NO: CON-043
DATE: June 2012

PRODUCT: XF3H Series Connectors
TYPE: Product Modification

**Modification Notice: Consumer Use Connector (XF3H series) –
External Contact Plating Change
Effective **May 2012****

Changes

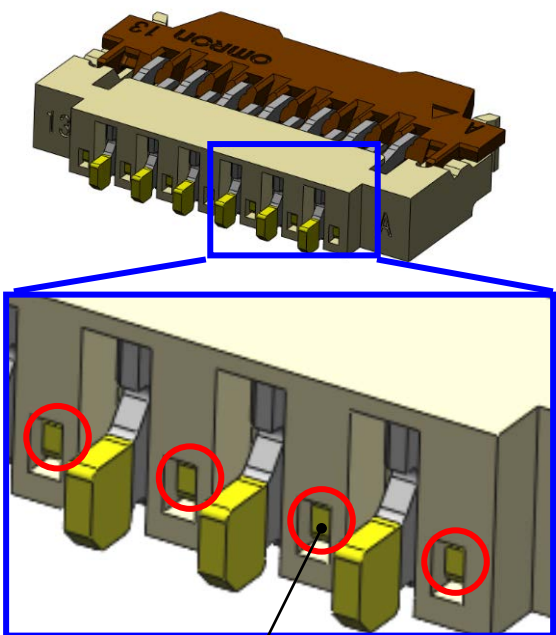
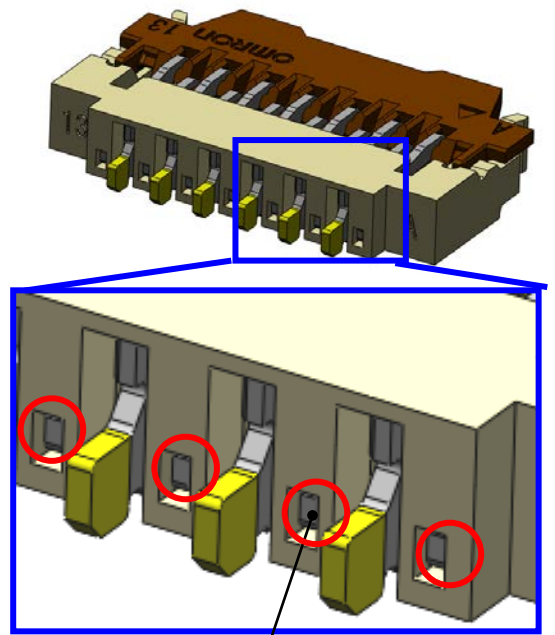
Before the change	After the change
<p>Externals part of odd contacts : Gold plating (Gold colored)</p>  <p>Externals part of odd contacts : Gold plating (Gold colored)</p>	<p>Externals part of odd contacts : Nickel plating (Silver colored)</p> <p>Externals part of even contacts : no change</p>  <p>Externals part of odd contacts : Nickel plating (Silver colored)</p>

There are ***no*** changes to characteristics or performance; the plating specifications for contact and terminal points remain the same.
